RE: Amendment to By-Product Material License #04-02624-03E

We are requesting an amendment to the subject license to include a modification to the C-14 calibration standard used in our Model 171 Radiosotope Flow Detector. Enclosed is Check No. 439150 in the amount of \$60.00.

QTY	ITEM	PART NO.	DESCRIPTION
	DR HARLAN	3/87	BECKMAN TITLE INST - ASSY, CALIBRATION CELL
	CHK		
	DSGN		
	ENGR		
	APPD		
		B SIZE	CODE IDENT NO 05721
			DWG NO. 010 - 523927-80
		SCALE -	INIT USEELS SHEET 1 OF 1

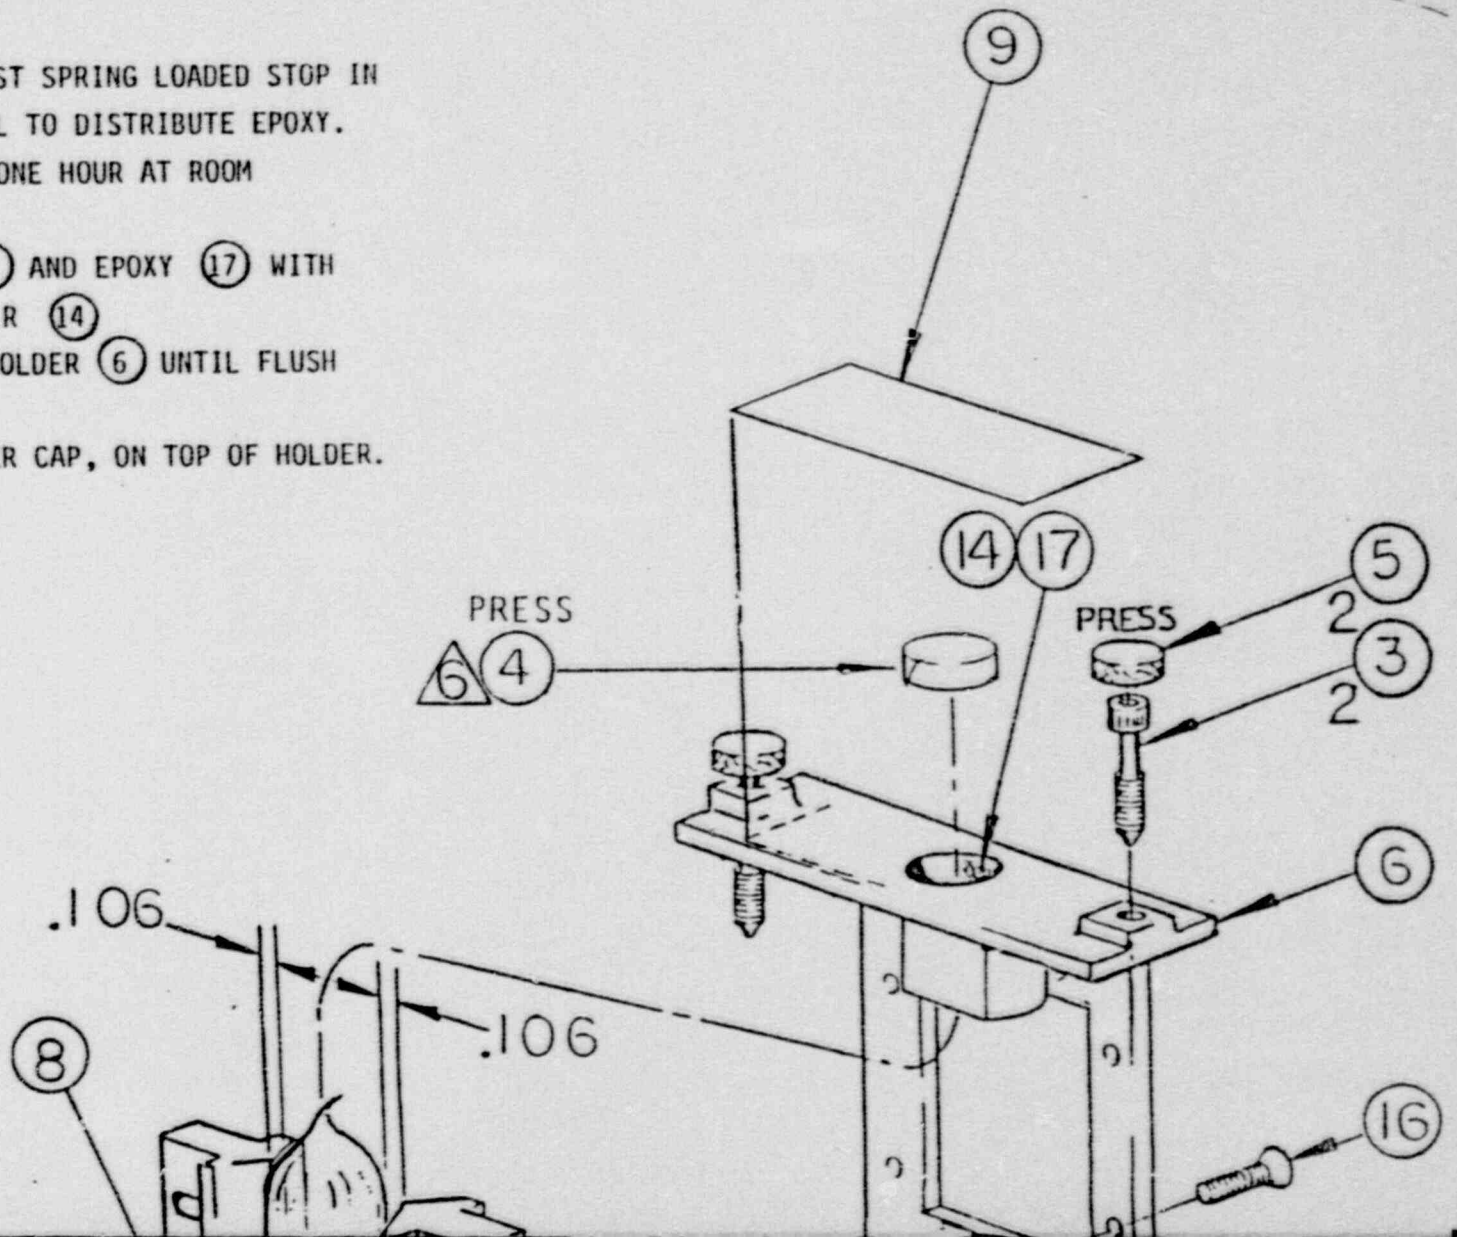
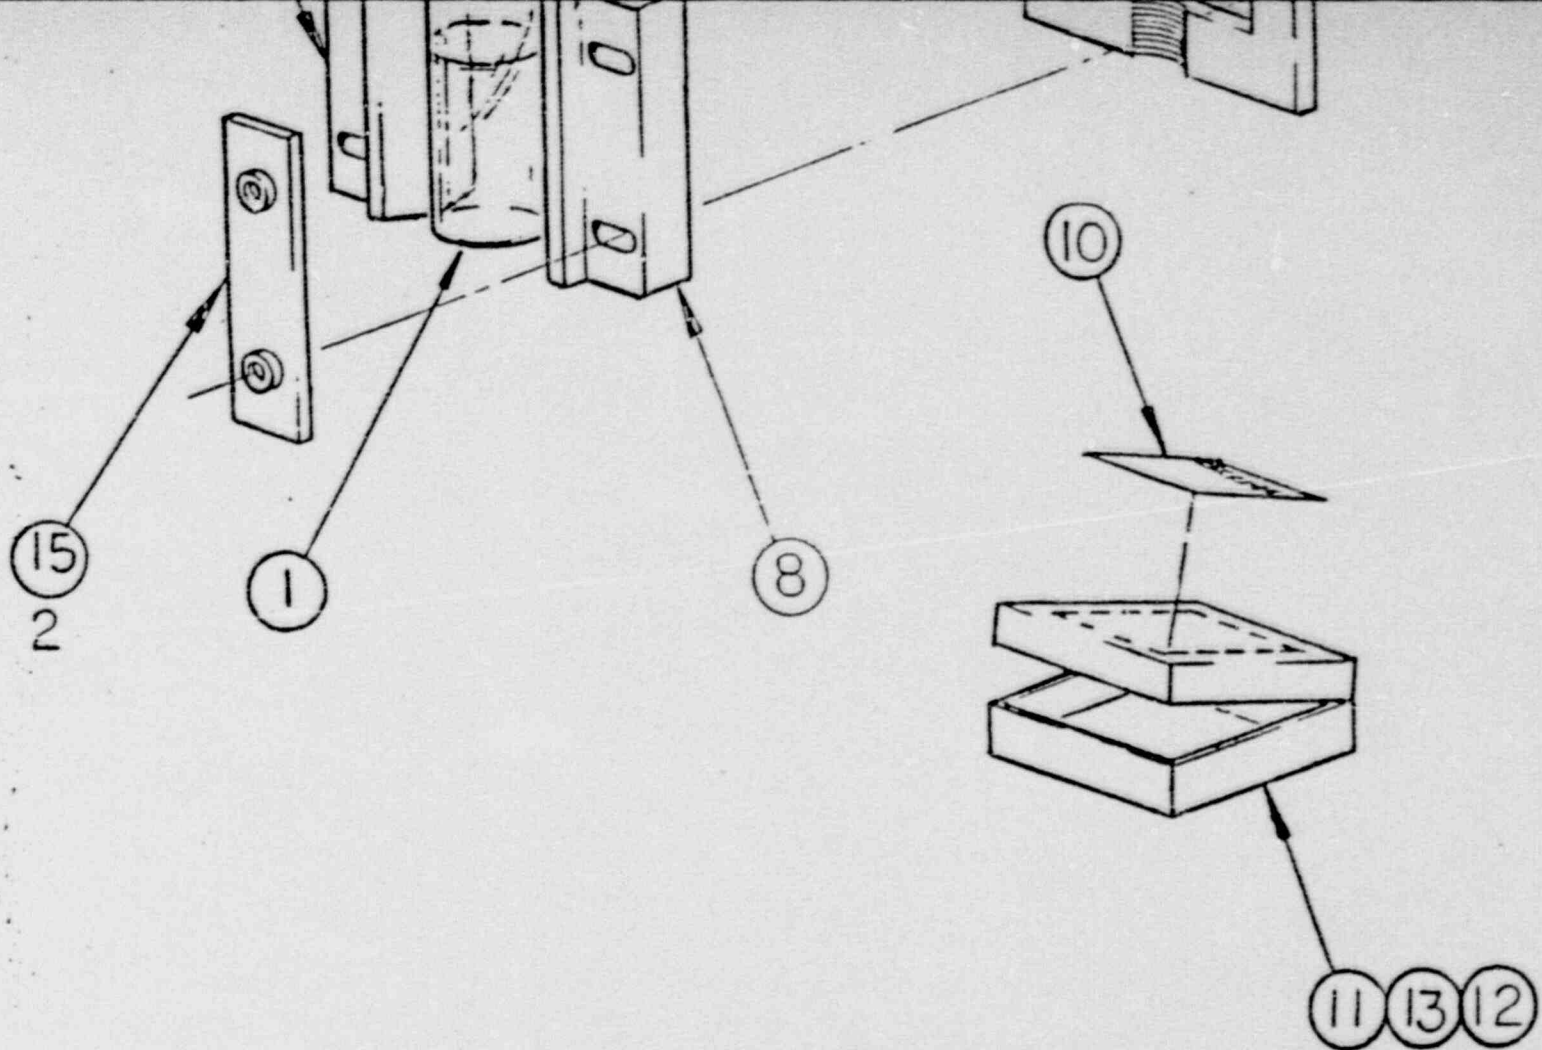
The function and the nominal level of radioactivity (0.025 uCi) of the unquenched C-14 sample will remain the same. The modifications involve changing from the currently used small glass ampule to a larger more rugged glass ampule. In addition, the C-14 labelled scintillation solution will be changed from pseudocumene to phenyl xlyethane, and the total volume will be changed from 0.4 ml to 4.0 ml.

The new ampule will be flame-sealed under nitrogen as is the currently used ampule. Finally, the screw-type supporting structure of the ampule will be replaced by an epoxy joint. The quality control procedures on this Beckman manufactured source will be just as stringent as those currently used.

Attached, in duplicate, are engineering drawings for the modified C-14 standard (see Attachments). Please amend the subject license to include the modifications indicated above.

1. PLACE VIAL (1) AND WEDGES (8) IN POSITION USING ASSEMBLY FIXTURE AND TIGHTEN SCREWS (16) INTO NUT PLATES (15).
2. STAND FIXTURE AND ASSEMBLY UPRIGHT AND ADD EPOXY (17) THROUGH ACCESS HOLE IN TOP OF HOLDER (6).
3. PULL BACK VIAL AGAINST SPRING LOADED STOP IN FIXTURE AND SPIN VIAL TO DISTRIBUTE EPOXY.
4. ALLOW EPOXY TO CURE ONE HOUR AT ROOM TEMPERATURE.
5. PAINT TOP OF VIAL (1) AND EPOXY (17) WITH WHITE LIQUID PAPER (14).
6. PRESS CAP (4) INTO HOLDER (6) UNTIL FLUSH WITH TOP OF HOLDER.
7. ATTACH LABEL (9) OVER CAP, ON TOP OF HOLDER.
